BROWNS FERRY NUCLEAR PLANT

IMPROVED STANDARD TECHNICAL SPECIFICATIONS

TENNESSEE VALLEY AUTHORITY

BROWNS FERRY NUCLEAR PLANT
APPLICATION OF SCREENING CRITERIA

Figure ~~3.5.M-1~~

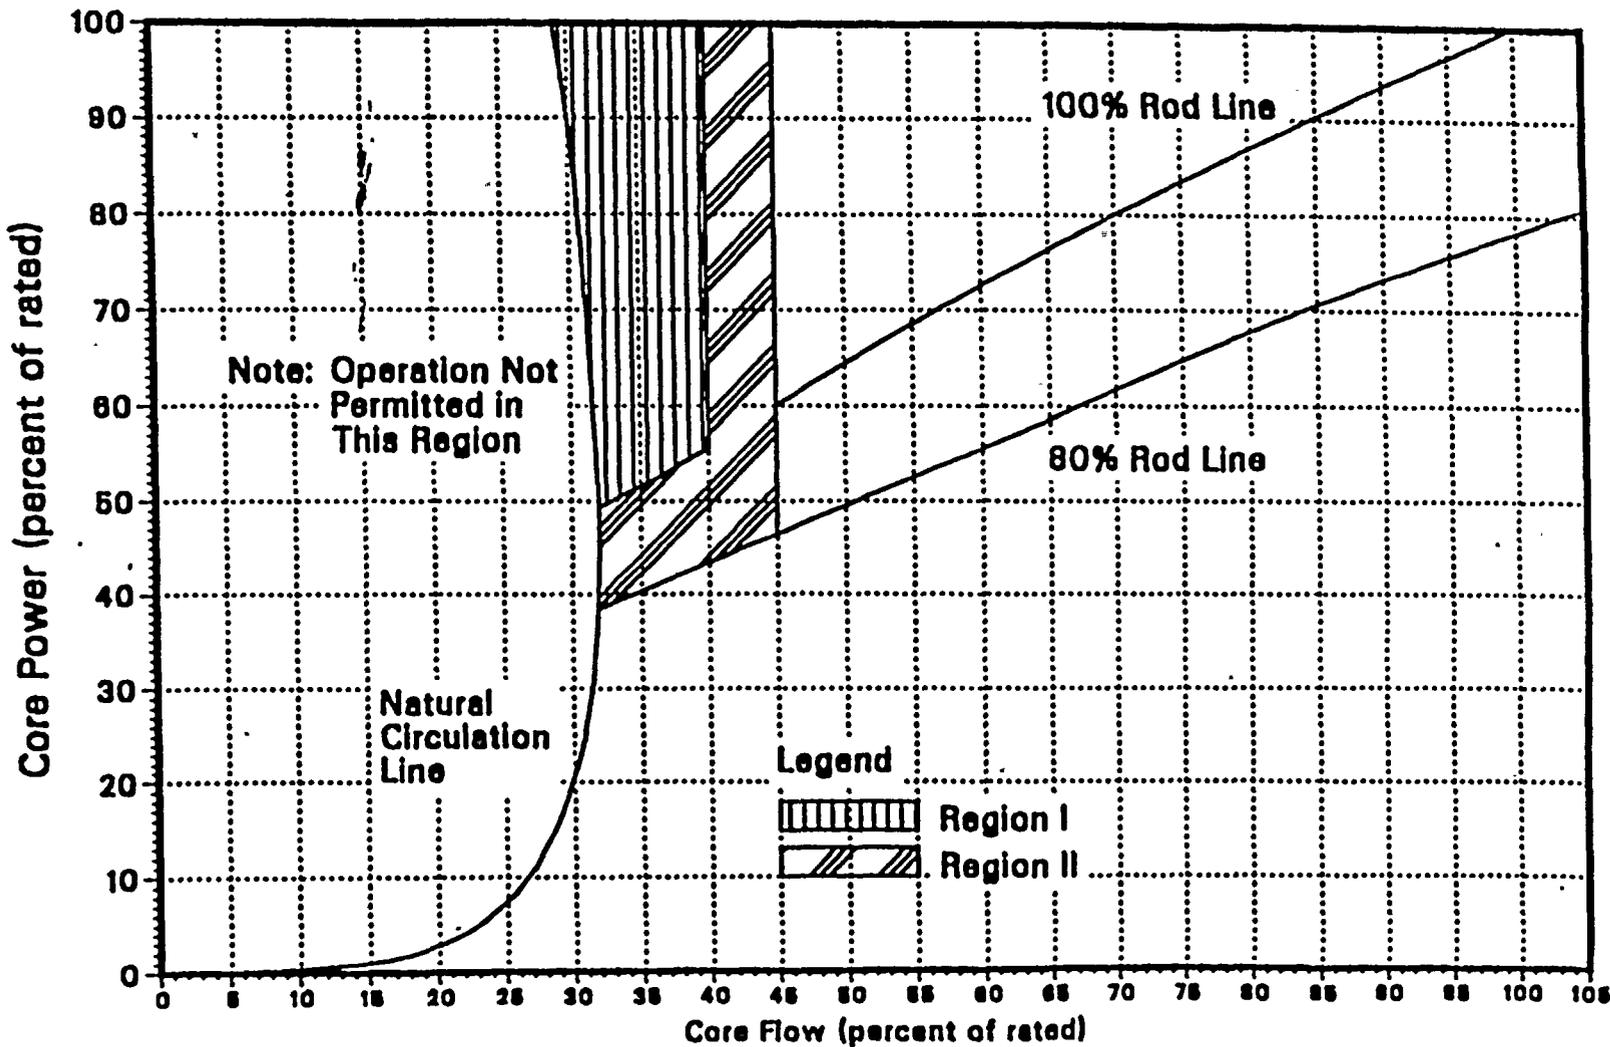
1. The reactor shall not be operated at a thermal power and core flow inside of Regions I and II of Figure 3.5.M-1.

2. If Region I of Figure 3.5.M-1 is entered, immediately initiate a manual scram.

3. If Region II of Figure 3.5.M-1 is entered:

1. Verify that the reactor is outside of Region I and II of Figure 3.5.M-1:

~~Figure 3.5.M-1~~

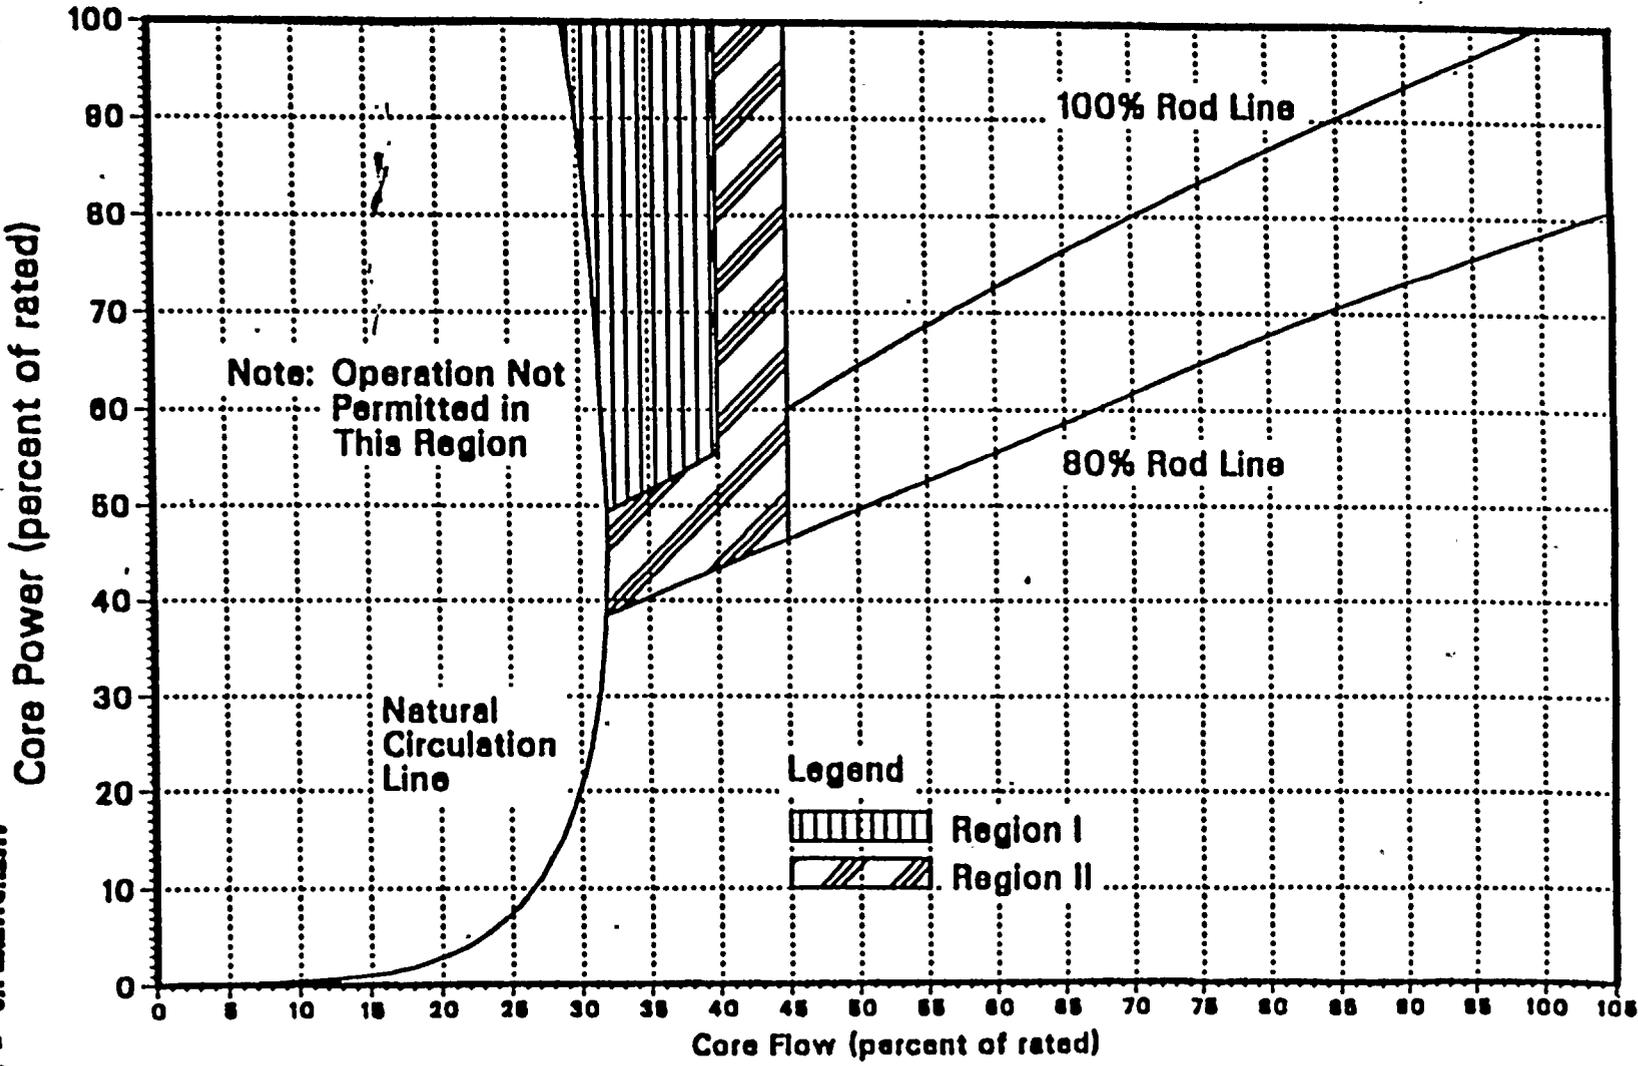
LA3

(A1)

3.4.1-1

- L2 Per CTS 3.5.M.3.a, if Region II of Figure 3.5.M-1 is not exited within 2 hours, the Specification is violated and CTS 1.0.C.1 applies requiring the plant be placed in Hot Standby within 6 hours and in Cold Shutdown within the following 30 hours. This provides actions for circumstances not directly provided for in the specifications and where occurrence would violate the intent of the specification. The BFN ISTS provides Action within the Specification which could be considered less restrictive than CTS. Action D allows 12 hours to be in MODE 3 (Hot Shutdown) and 36 hours to be in MODE 4 (Cold Shutdown). The proposed Action is considered less restrictive since 12 hours is allowed to place the unit in Hot Shutdown versus the 6 hours allowed to place the unit in Hot Standby per CTS.

(A1) Figure 3.4.9-1
~~Figure 3.6-1~~

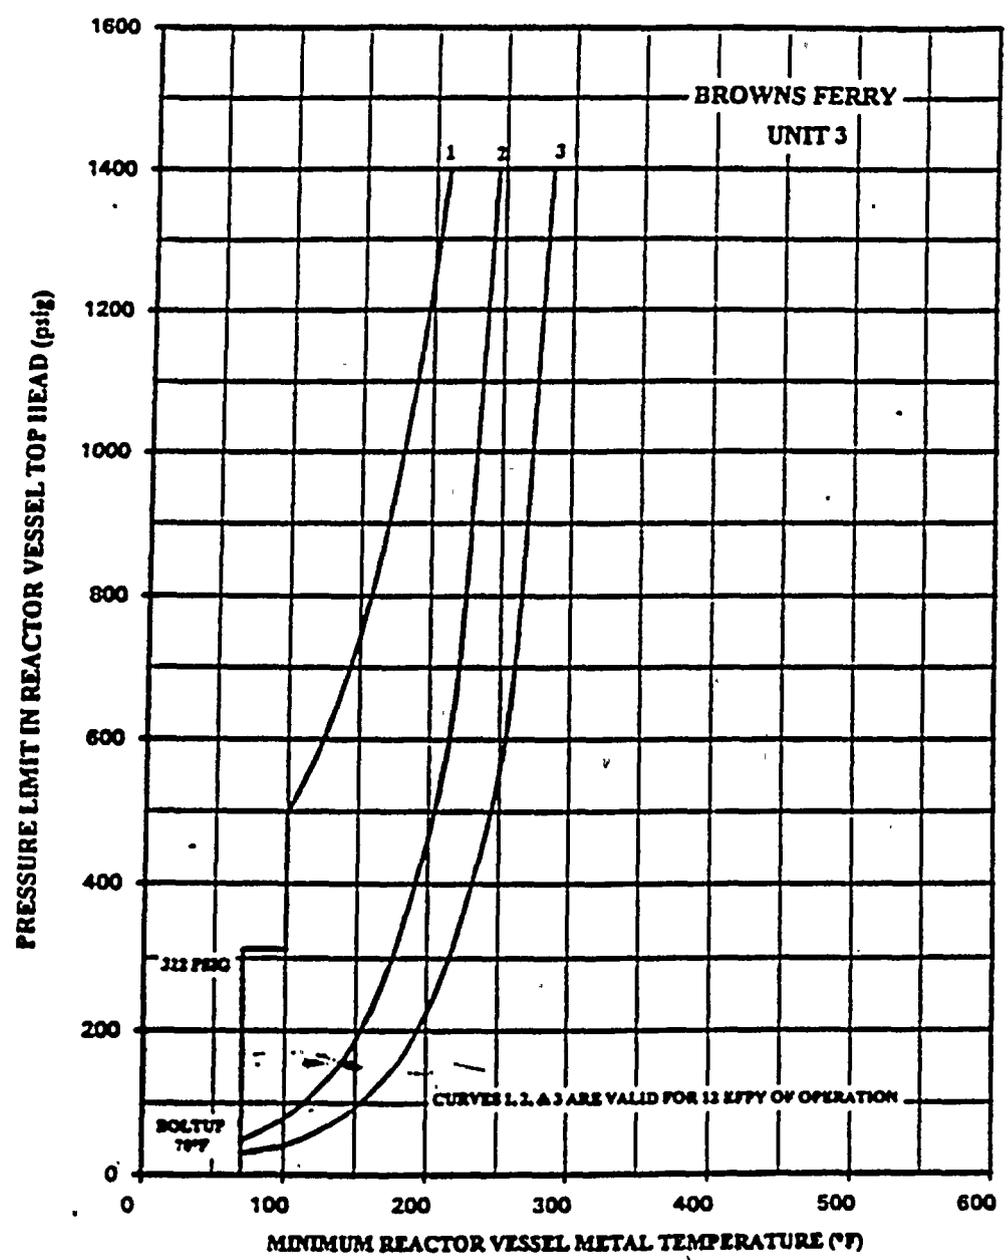
(LA1)

Curve No. 1
Minimum temperature for pressure tests such as required by Section XI. Minimum temperature of 189°F is required for test pressure of 1,100 psig.

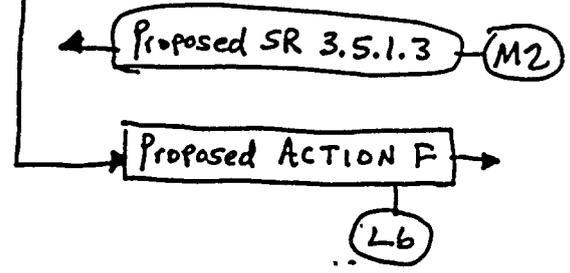
(A1) 2. No additional surveillances are required.

ACTION G+H 3. With two or more of the above required ADS valves inoperable, be in at least a HOT SHUTDOWN CONDITION within 12 hours and reduce reactor steam dome pressure to ≤ 105 psig within 24 hours. (36) (L2) (150) (L5)

ACTIONS G Required Action H.1 (LEO 3.0.3) (M1) MODE 2 within 7hrs (L12) (for ADS only) MODE 3 within 13hrs (L12) MODE 4 within 37hrs (L12)

Figure ~~3.5.M-1~~ BFN Power/Flow Stability Regions

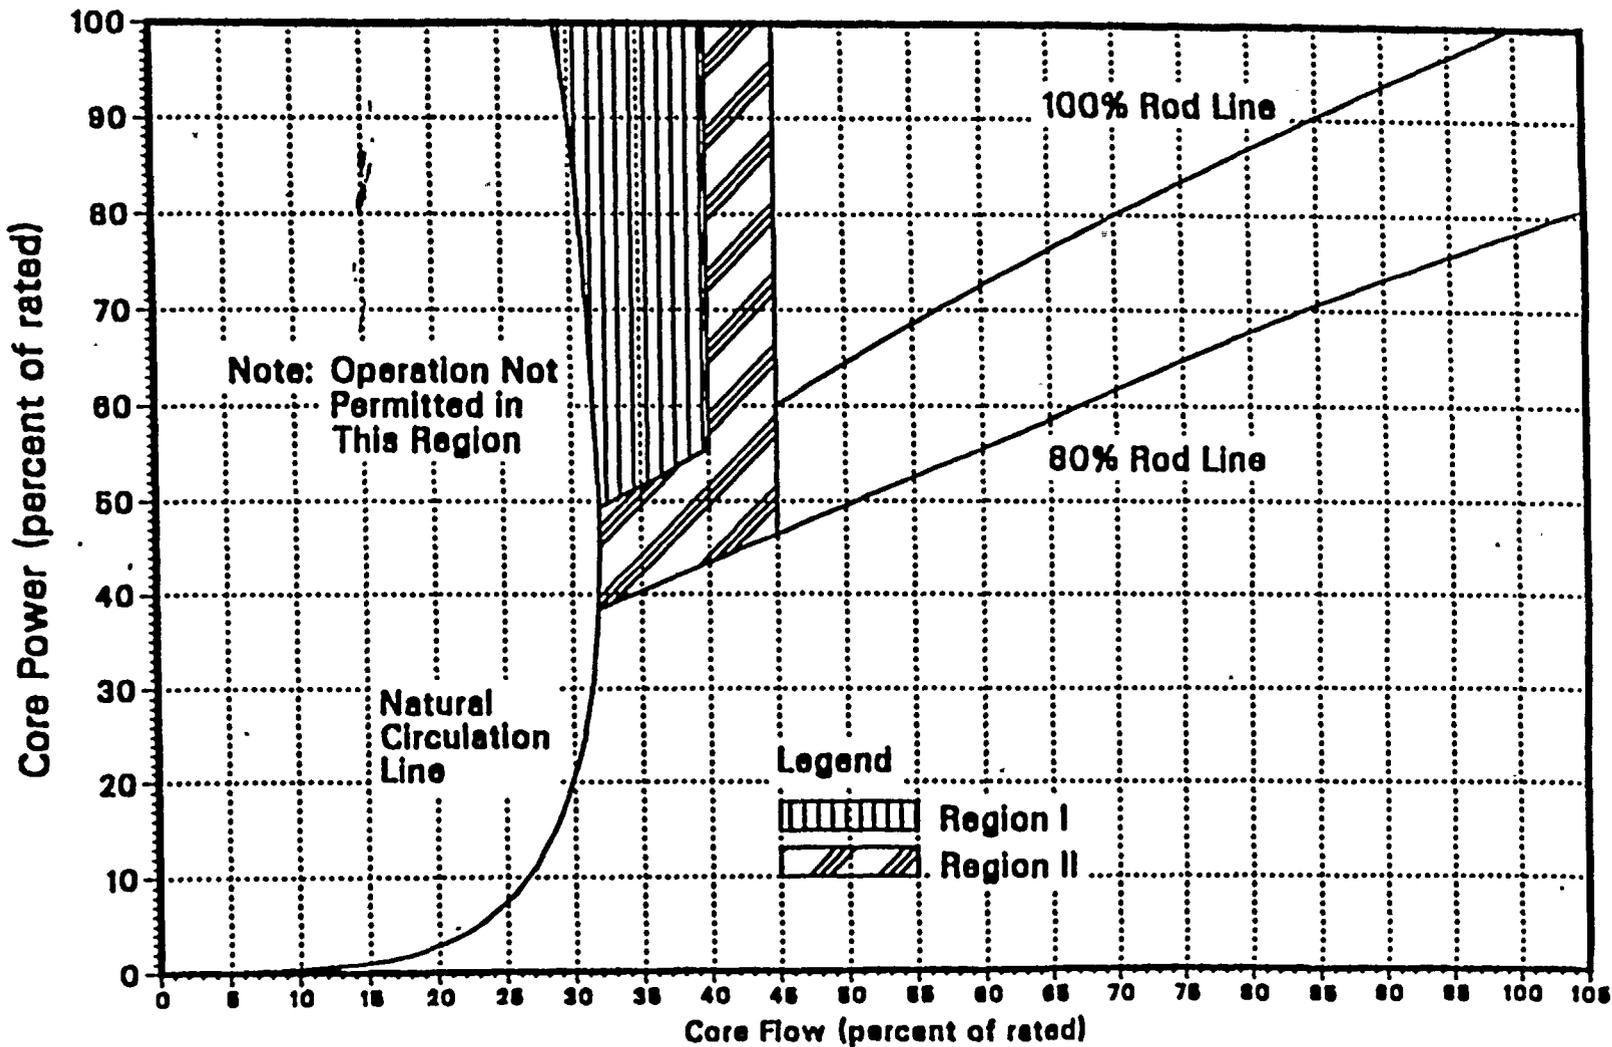
1. The reactor shall not be operated at a thermal power and core flow inside of Regions I and II of Figure 3.5.M-1.

2. If Region I of Figure 3.5.M-1 is entered, immediately initiate a manual scram.

3. If Region II of Figure 3.5.M-1 is entered:

1. Verify that the reactor is outside of Region I and II of Figure 3.5.M-1:

~~Figure 3.5.M-1~~

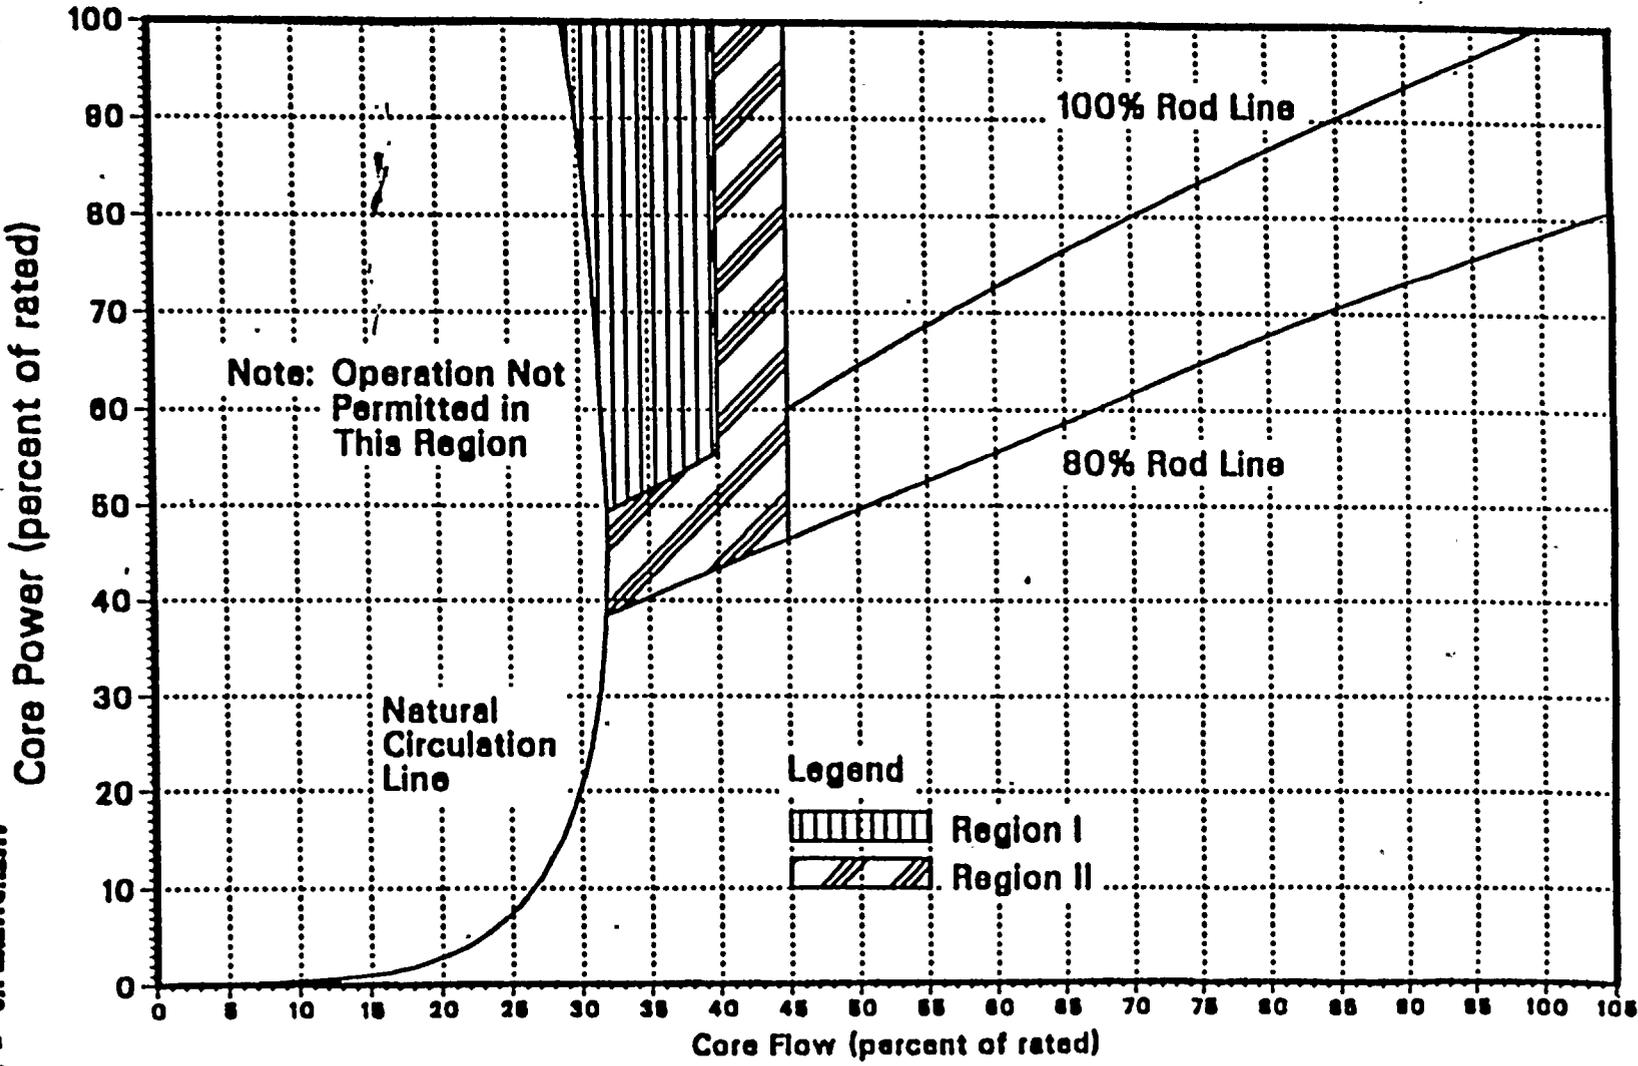
(LA3)

(A1)

- L2 Per CTS 3.5.M.3.a, if Region II of Figure 3.5.M-1 is not exited within 2 hours, the Specification is violated and CTS 1.0.C.1 applies requiring the plant be placed in Hot Standby within 6 hours and in Cold Shutdown within the following 30 hours. This provides actions for circumstances not directly provided for in the specifications and where occurrence would violate the intent of the specification. The BFN ISTS provides Action within the Specification which could be considered less restrictive than CTS. Action D allows 12 hours to be in MODE 3 (Hot Shutdown) and 36 hours to be in MODE 4 (Cold Shutdown). The proposed Action is considered less restrictive since 12 hours is allowed to place the unit in Hot Shutdown versus the 6 hours allowed to place the unit in Hot Standby per CTS.

(A1) Figure 3.4.9-1
~~Figure 3.6-1~~

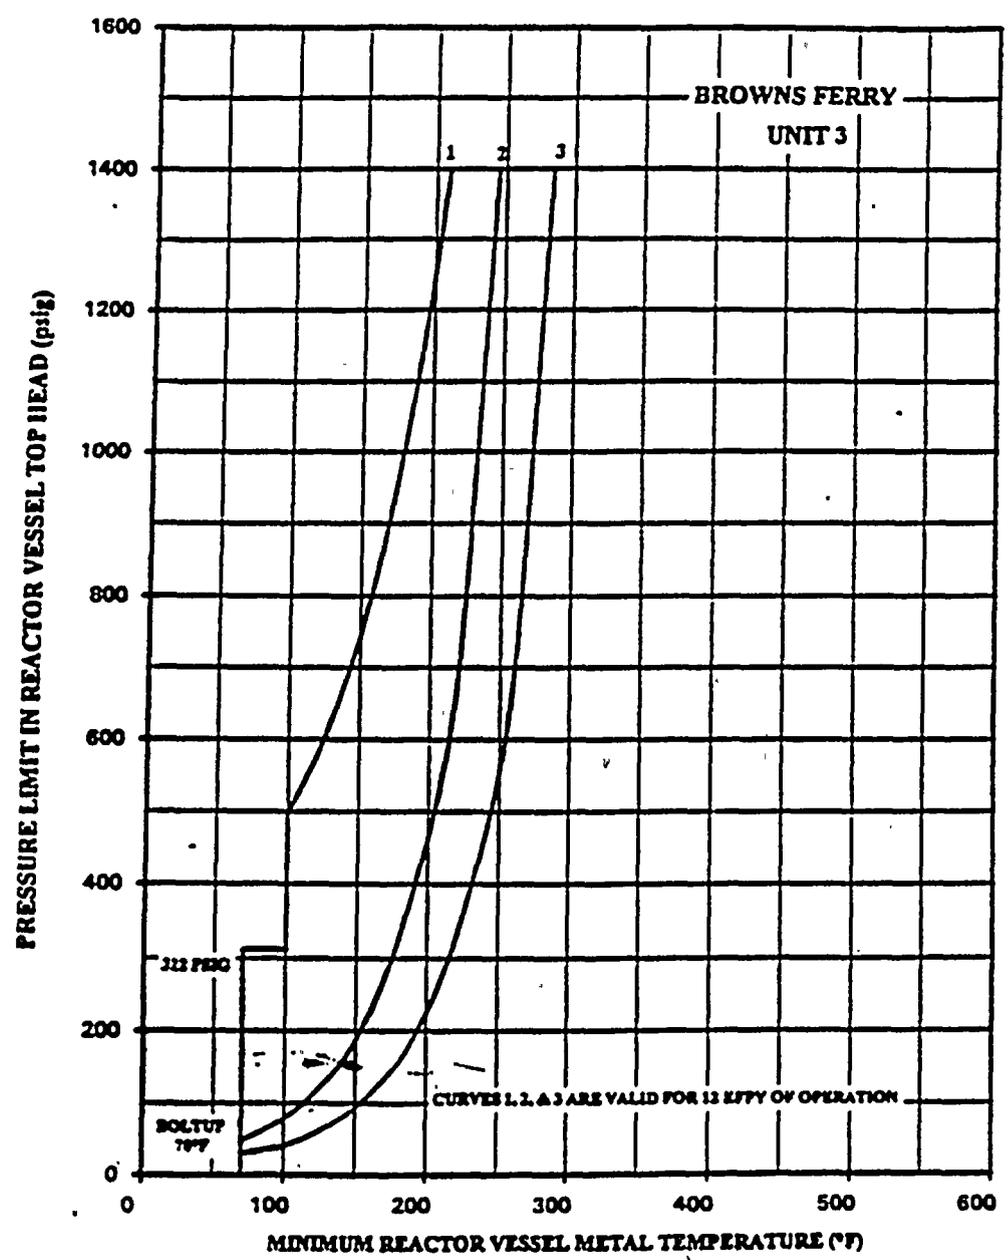
Curve No. 1
Minimum temperature for pressure tests such as required by Section XI. Minimum temperature of 189°F is required for test pressure of 1,100 psig.

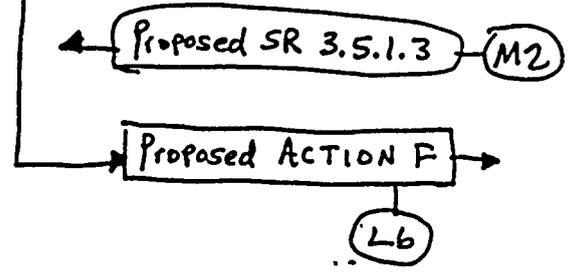
(A1) 2. No additional surveillances are required.

ACTION G+H 3. With two or more of the above required ADS valves inoperable, be in at least a HOT SHUTDOWN CONDITION within 12 hours and reduce reactor steam dome pressure to ≤ 105 psig within 24 hours. (36) (L2) (150) (L5)

ACTIONS G Required Action H.1 (LEO 3.0.3) (M1) MODE 2 within 7hrs MODE 3 within 13hrs (L12) (for ADS only) MODE 4 within 37hrs (L12)
